CARRIER, MAINTENANCE, FULL TRACKED, FV434 MKS 1 AND 1/1

MODIFICATION INSTRUCTIONS AND INDEX

MODIFICATION INSTRUCTION NO. 1

SUBJECT: EMER TV E 107/4 Modification Instructions No. 1 to No. 27

Fig 2 Fire extinguisher rear hull

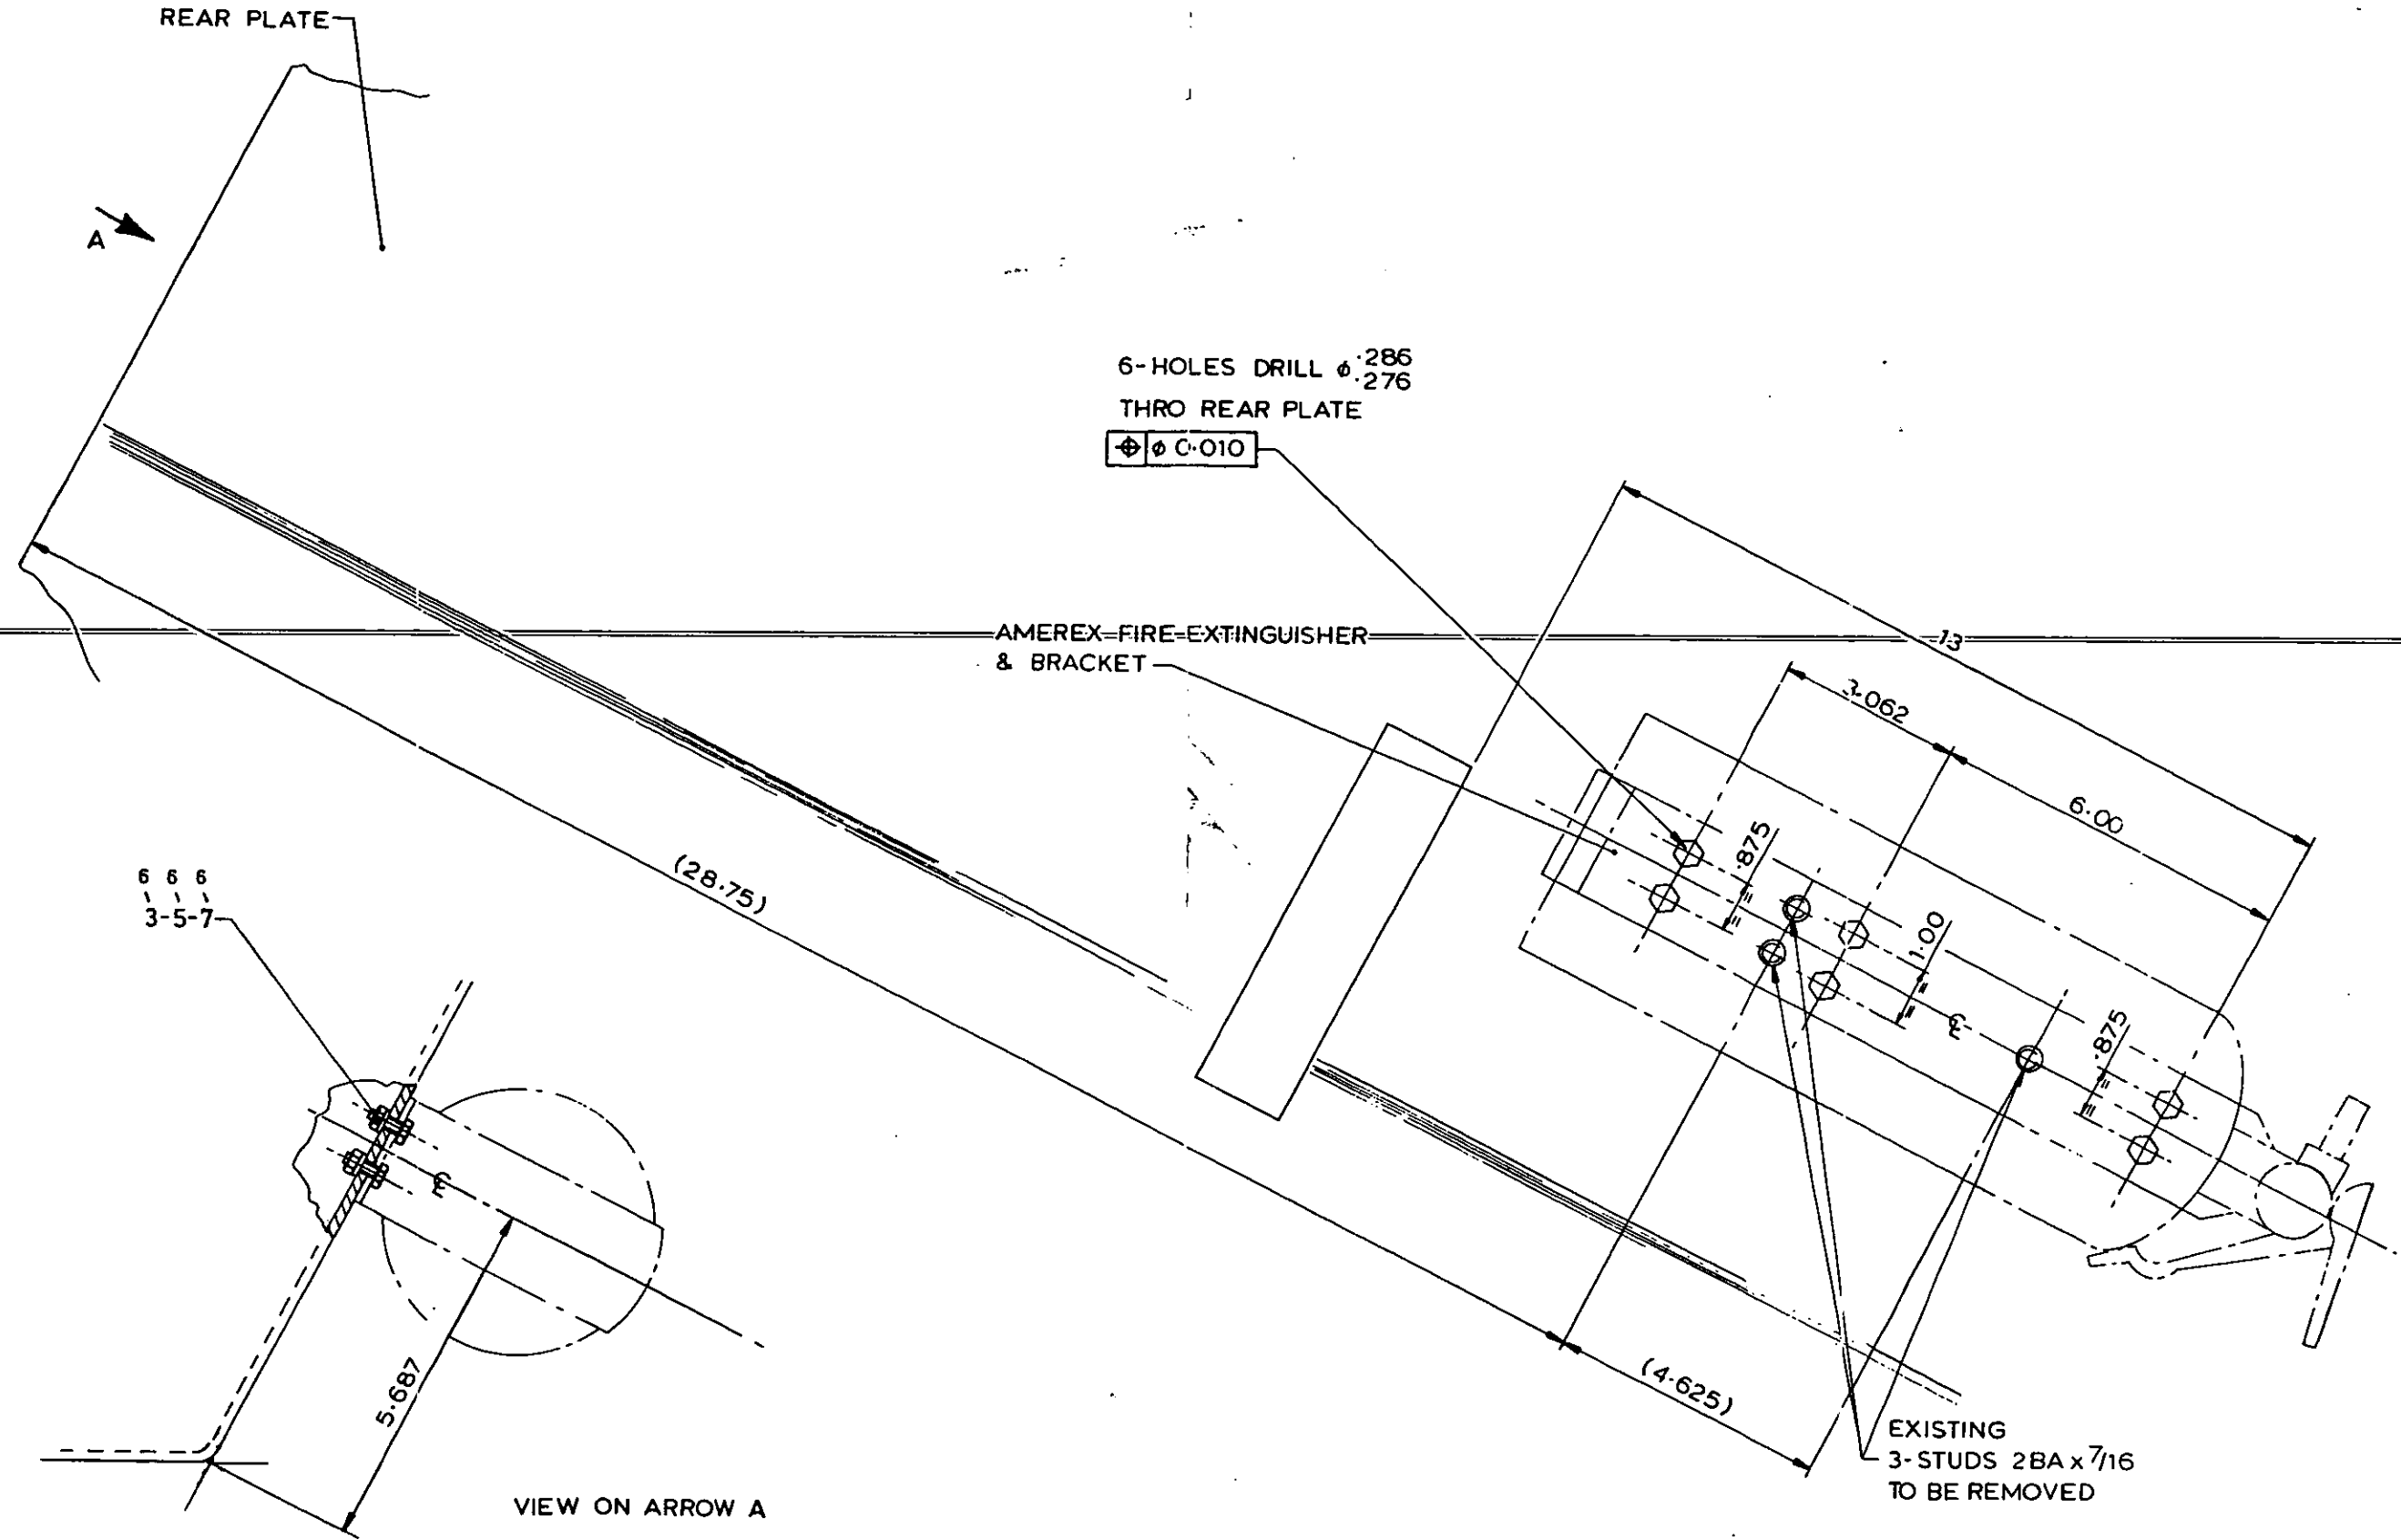
9.1 Remove existing extinguishers and brackets from rear plate (1-off) and front plate upper (2-off). Return extinguishers to stores, to be used for replacement of internal hand extinguishers.

Fig 1 Location of amber beacon on vehicle

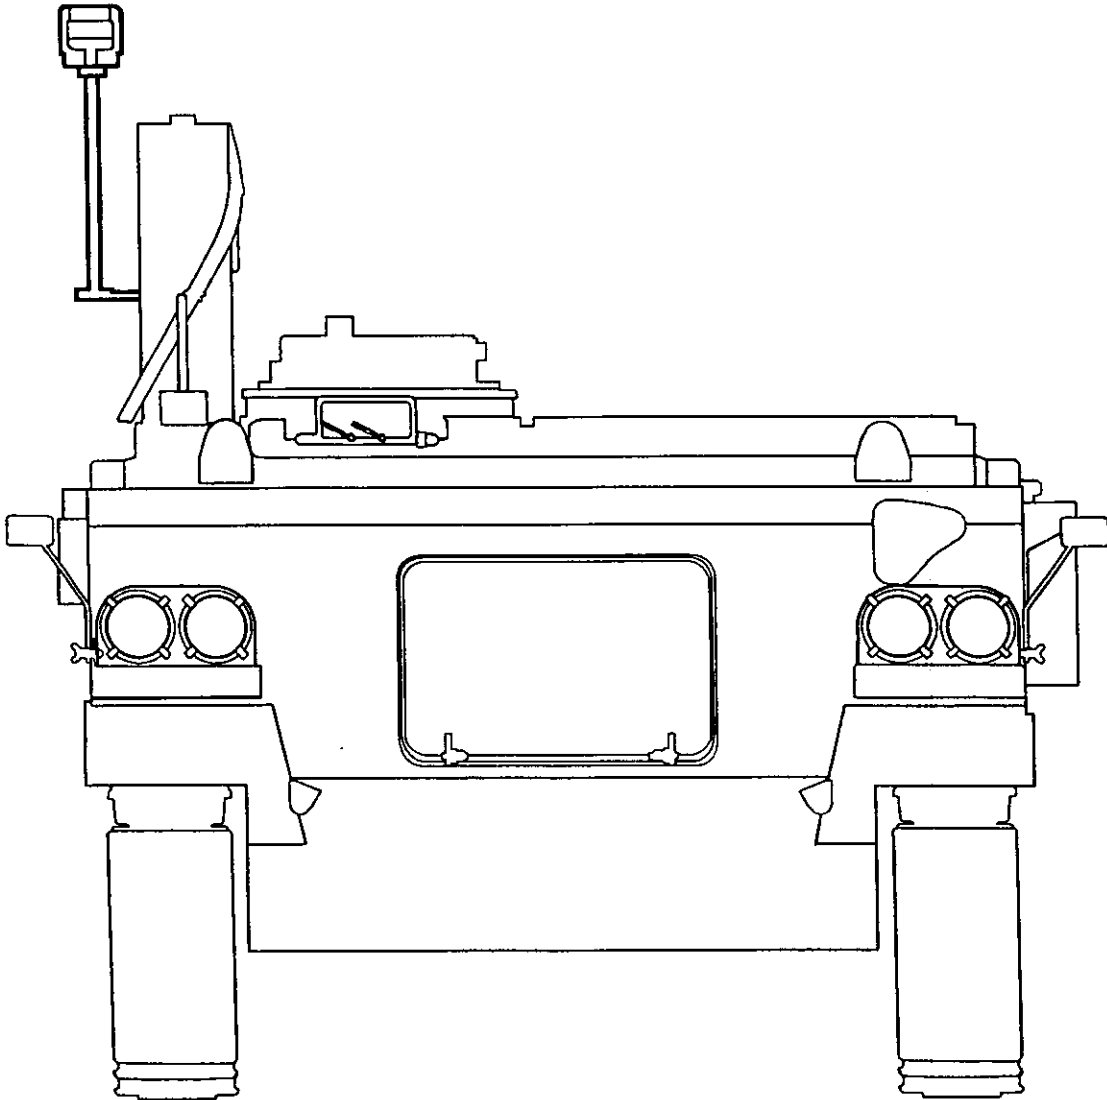
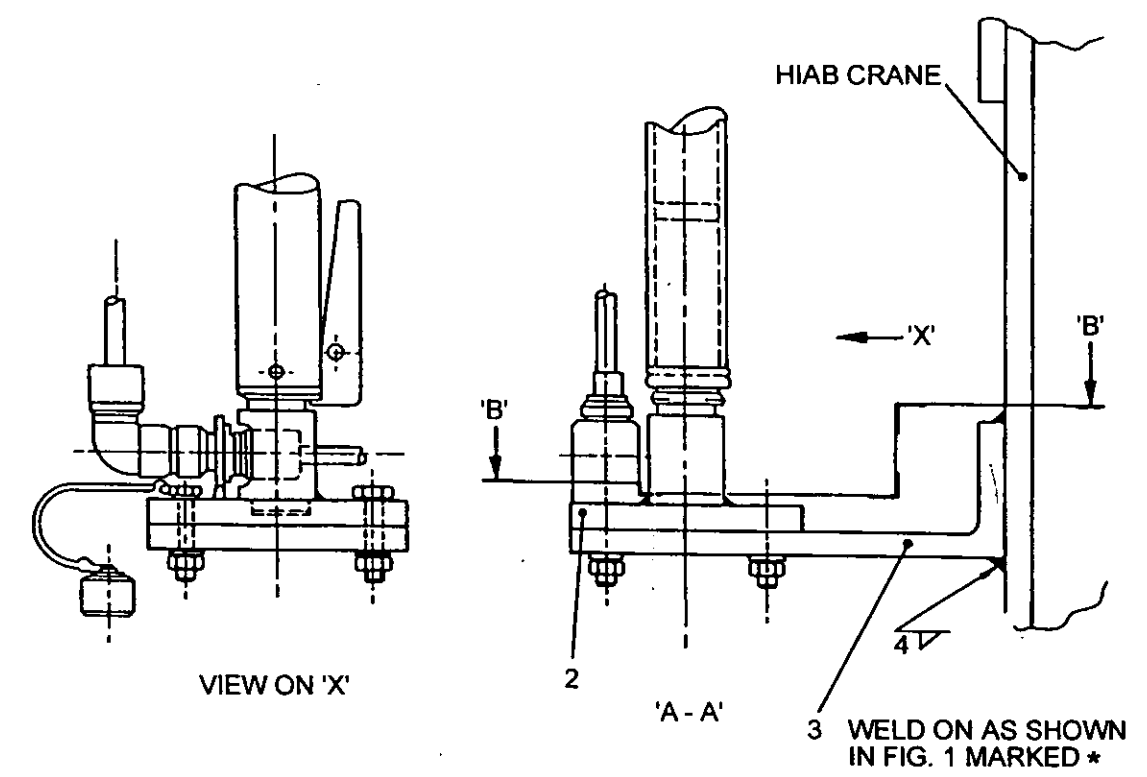
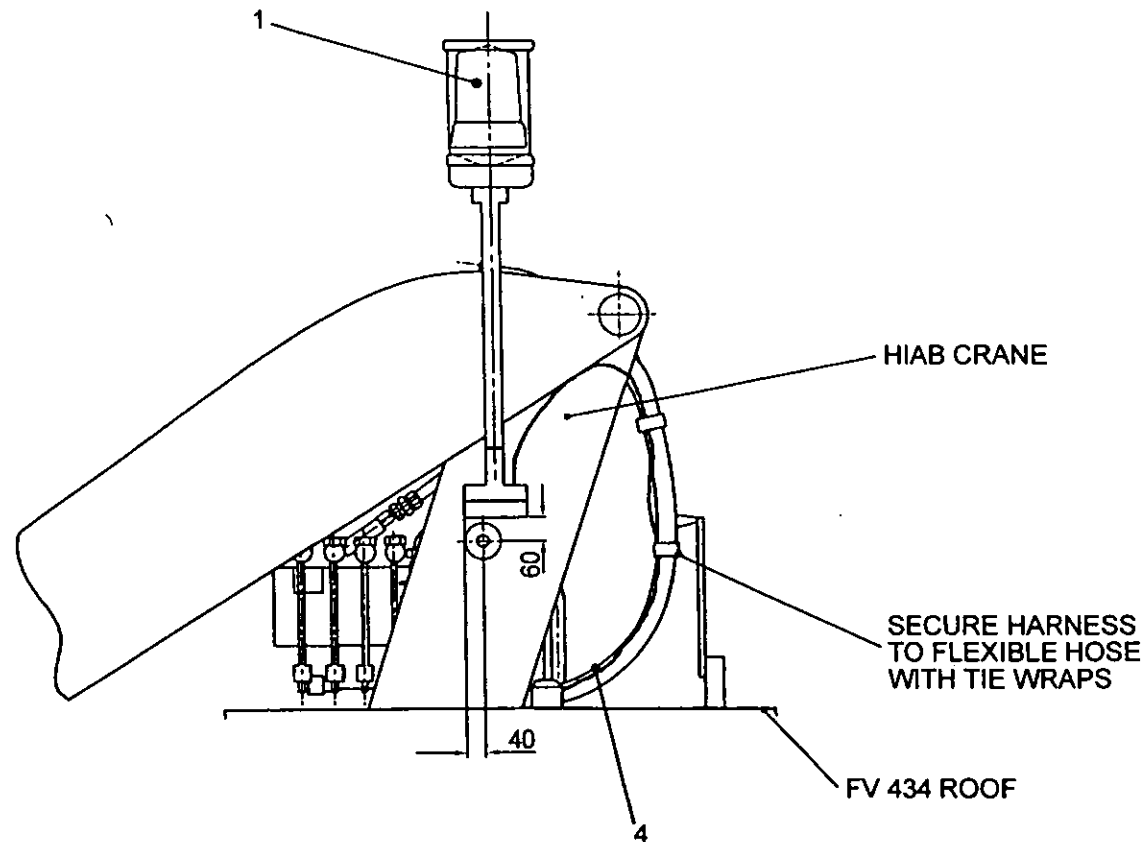
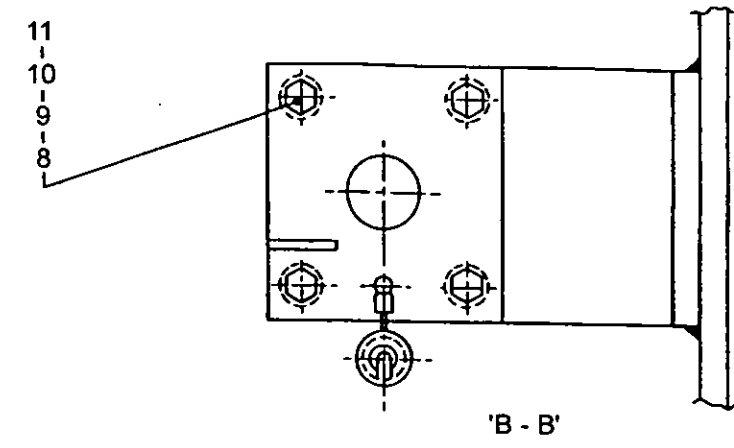
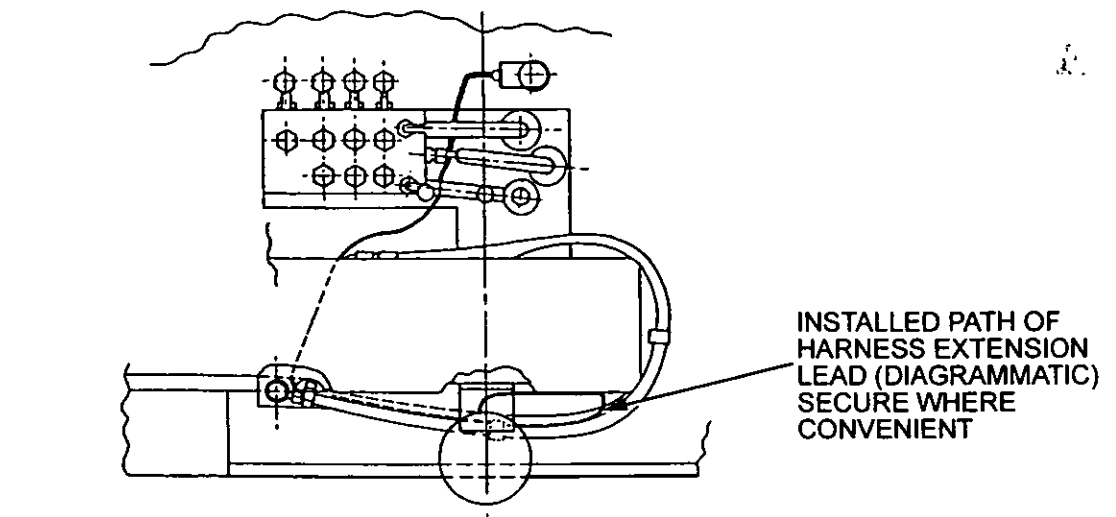
1 This instruction details the initial fitting/relocation of an amber rotating beacon in a revised location. The original modification instruction, AESP 2350-T-252-811 Mod Instr No. 1, E107/4 Mod Instr No. 26 was cancelled due to a foul of the mounting bracket on the hydraulic pipelines of the valve control block.

9.1 If AESP 2350-T-252-811 Mod Instr No. 1, E107/4 Mod Instr No. 26, amber rotating beacon modification has been embodied on the vehicle, it is to be removed in accordance with Sub-Para 9.2 and refitted in accordance with Sub-Para 9.3 onwards. If the amber beacon modification has not been fitted go to Sub-Para 9.3.

9.2 Remove the amber beacon assy (item 1) from the base assy (item 2), remove the base assy and harness (item 2 and 4) with fixings (item 8, 9, 10 and 11) from bracket (item 3). Remove bracket (item 3) from the HIAB crane and restore the paint finish to current regulations. Retain all items.

Fig 1 Removal of ammunition tray

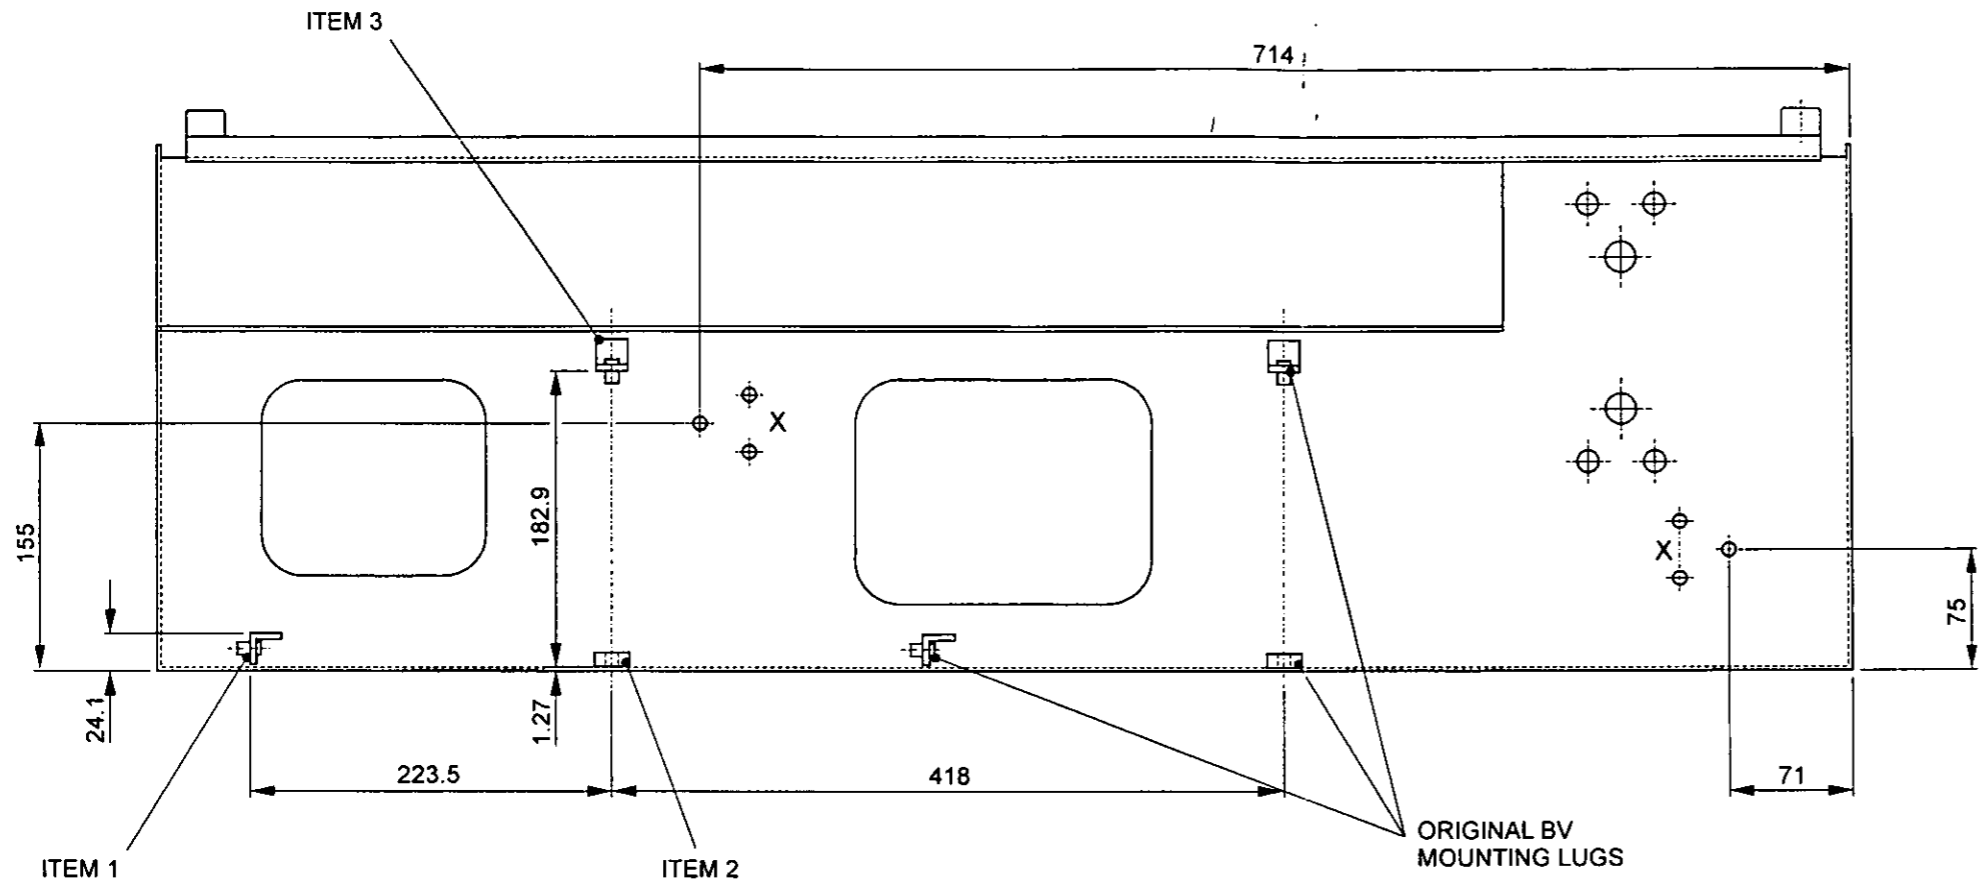
9.2 Remove and retain the BV tray (item 17) and fittings. Completely remove and discard both sections of the ammunition tray (item 18) from the engine cover.
